Item Name: 205 Skidtube bent detail

DRAWING NO. D2580	TITLE 205 SKIDTUBE ASSEMBLY	REV. D	DART AEROSPACE LTD ENGINEERING ORDER		D.E.O. NO. D2580-D-1	SHEET NO. SHEET 1 OF 1	SCALE NTS
DRAWN <i>UP</i>	CHECKED <i>L</i>	MFG. APPR. <i>E</i>	APPROVED <i>MP</i>		DE APPR. <i>H</i>		
DATE 10.09.22	DATE 10.11.04	DATE 10.11.04	DATE 10/11/04		DATE 10.11.04

PURPOSE:

CHANGE ALL WELDED CROSSBOLT SPACERS TO SWAGED SPACERS

SECTION D-D & SECTION H-H ARE AMENDED AS FOLLOWS:

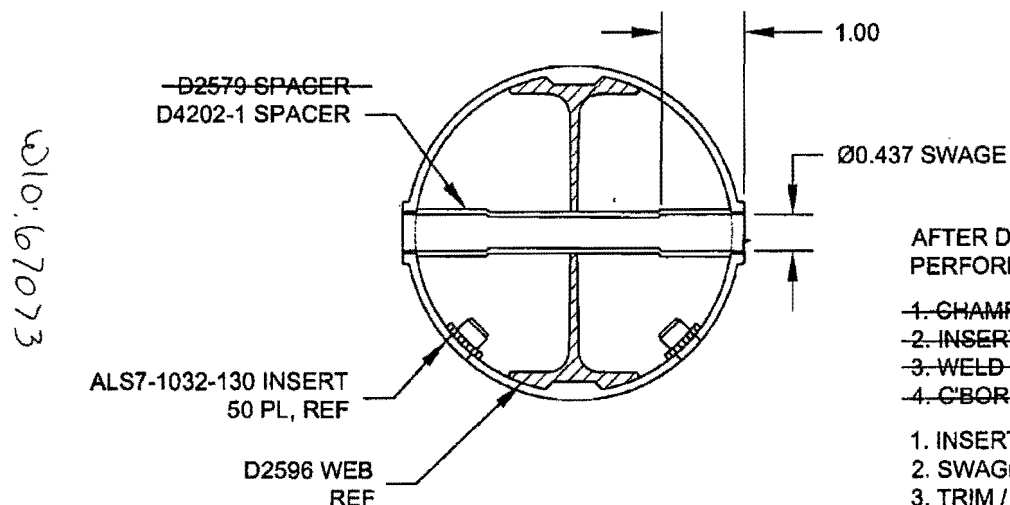
PARTS LIST IS AMENDED AS FOLLOWS:

WAS

QTY	QTY	PART NUMBER	DESCRIPTION
-041	-045		
20	24	D2579	CROSS BOLT SPACER

- ~~1. CHAMFER HOLE 0.050 X 45°~~
- ~~2. INSERT D2579 SPACER (20 PLACES)~~
- ~~3. WELD INTO PLACE AND GRIND FLUSH~~
- ~~4. C-BORE D2579 SPACER TO Ø0.437 X 1.00 DEEP~~

20	24	D4202-1	SPACER
----	----	---------	--------

1. INSERT D4202-1 SPACER, 20 PL (-041) OR 24 PL (-045)
2. SWAGE TO Ø0.437 X 1.00 DEEP PER QSI 002
3. TRIM / GRIND FLUSH PER QSI 002
